INDESIT company

Model type:
DV620IX

Commercial code:
F029929

n1045069: Modification of racks and dispenser lid on EVO3 dishwashers

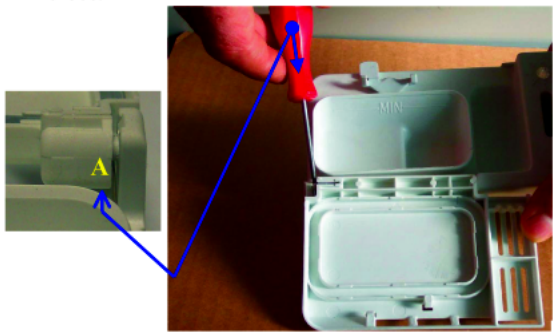
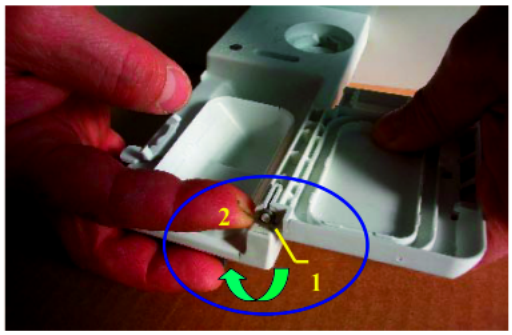
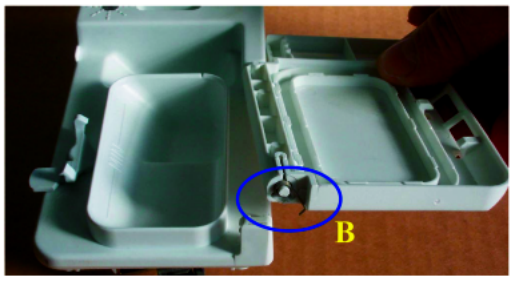
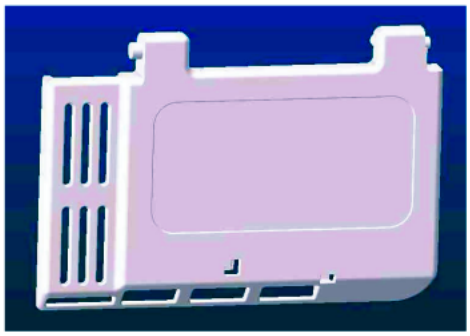
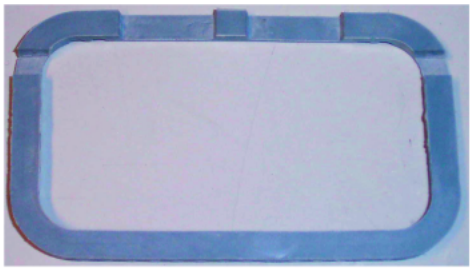
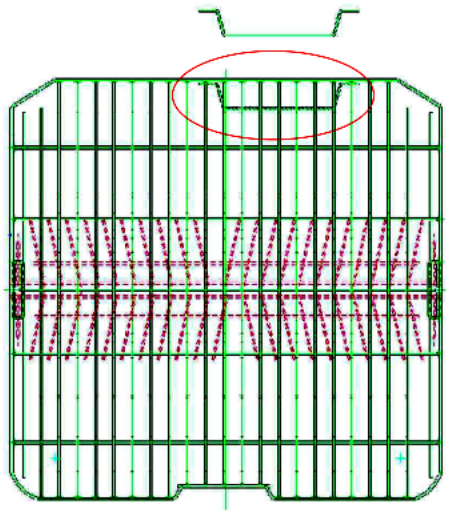
To obtain better dissolving of the detergent during the wash cycle, the following modifications have been made to EVO3 dishwashers:
- new dispenser lid, replacement code 098134 (see figure N1045069FIG4) created;
- upper racks modified with lid catch angle changed from 9° to 16° (see figure N1045069FIG5);
- MultiSystem lower racks modified with insertion of a spacer wire at the electric dispenser (see figure N1045069FIG6).

The upper and lower racks have the same spare part codes as the premodification items; Replacements Warehouse stocks have been replaced.

Lid installation instructions:
1) prise the lid out of the dispenser seat using a small screwdriver at point A (figure N1045069FIG1);
2) replace the lid, checking that release spring B (figure N1045069FIG2) is in place; before fitting the new lid load the spring from position 1 to position 2 (figure N1045069FIG2);
3) fit the lid in its special seat and check for correct operation (figure N1045069FIG3).
Lid closing may be harder for the first few cycles after replacement, due to settling of the material.

n1045083: Modification of filters on EVO3 60 cm dishwashers

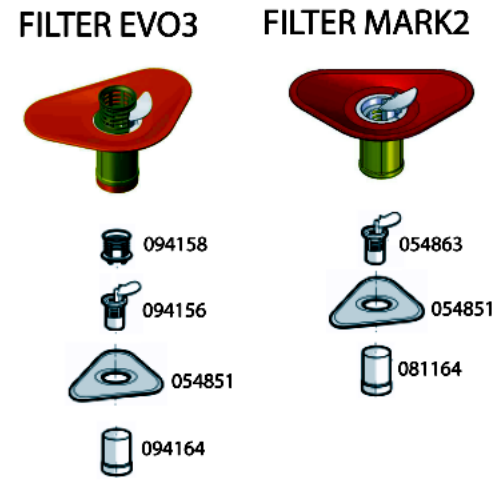
All dishwasher models affected by this modification have been equipped with the items listed below, in order to solve the drain pump clooging problem.

Introduction of:
Cylindrical plastic filter code 081164
Central filter code 054863

Elimination of:
Cylindrical plastic filter code 094164
Central filter code 094156
Central filter grid code 094158

The modification has been introduced progressively, starting from serial no. 40516.0001.

n1045098: Different position of electric distributor.

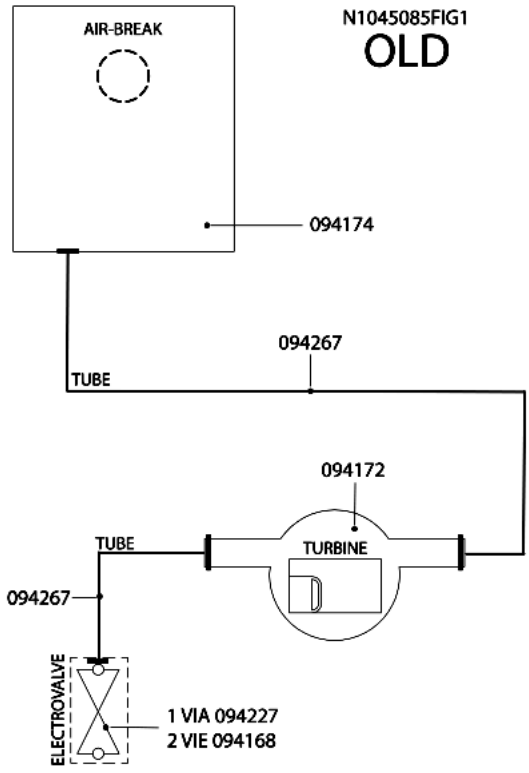
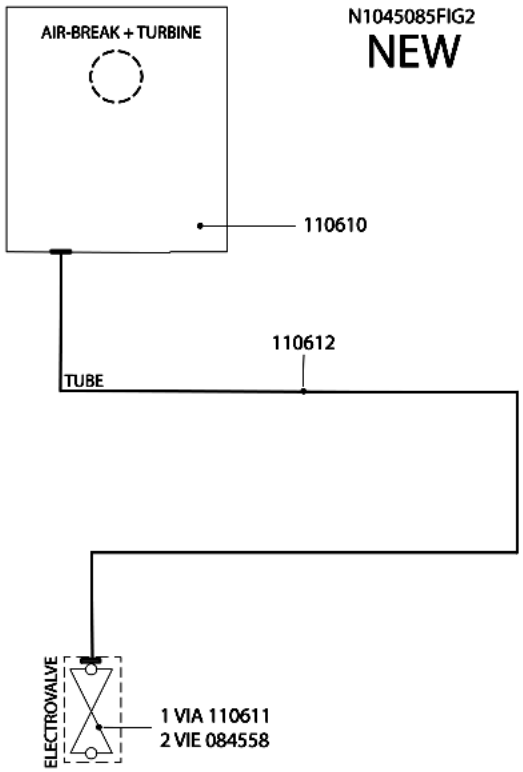
The position of the electric distributor has been changed as shown in the attached illustration.
The new machines have a new industrial code.

Introduced items:
C00109659 upper rack
C00109698 inside door

Premodification items:
C00097164 upper rack
C00095276 inside door

n1045127: New airbreak - solution of water spurts leaking from base LVS 60 CM

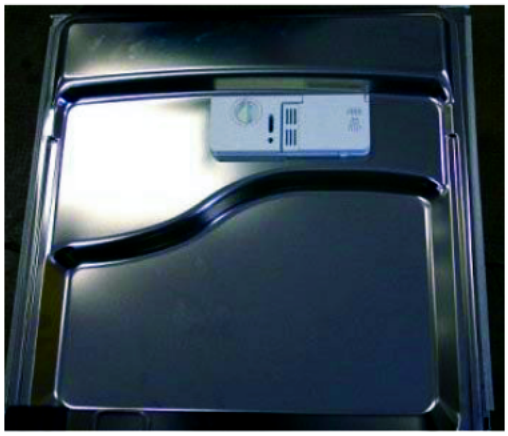
From serial number 50930.0001, to solve the problem of water spurts emitted from the lower right and left side of the door the following modifications were introduced in production:

1-Airbreak without insert to allow the necessary pressure venting
2-Honeycomb top panel to protect the kitchen unit from any steam emitted (only on built-under models)
3-Tank seal length increased by 3 cm to improve water tightness
4-Die-cut roof sound-deadening panel
5-Three clips for correct fixing of the tank base seal (in production from serial number 50701.0001)

New parts:
C00141308 - Airbreak
C00141310 - Honeycomb top panel (built-under versions only)
C00141317 - Tank seal
C00141314 - Roof sound-deadening panel
C00140679 - Tank base seal fixing clip

Premodification parts
C00110610 - Airbreak
C00116110 - Tank seal
C00097300 - Roof sound-deadening panel

1) AIRBREAK REPLACEMENT
It is mandatory to use the new part; in the event of replacement with premodification appliances proceed as follows:
- replace the airbreak with the new part C00141308
- if present, refit the roof sound-deadening panel after cutting out a 10x10 cm square from the rear left-hand corner
- on the built-under version, fit honeycomb panel C00141310 on the top of the appliance
- replace tank seal with the new seal P/N C00141317

2) CHANGING THE TANK SEAL
On appliances with serial number from 40101.0001 to 50930.0001, you can use the new tank seal P/N C00141317 after cutting 1.5 cm off each end.
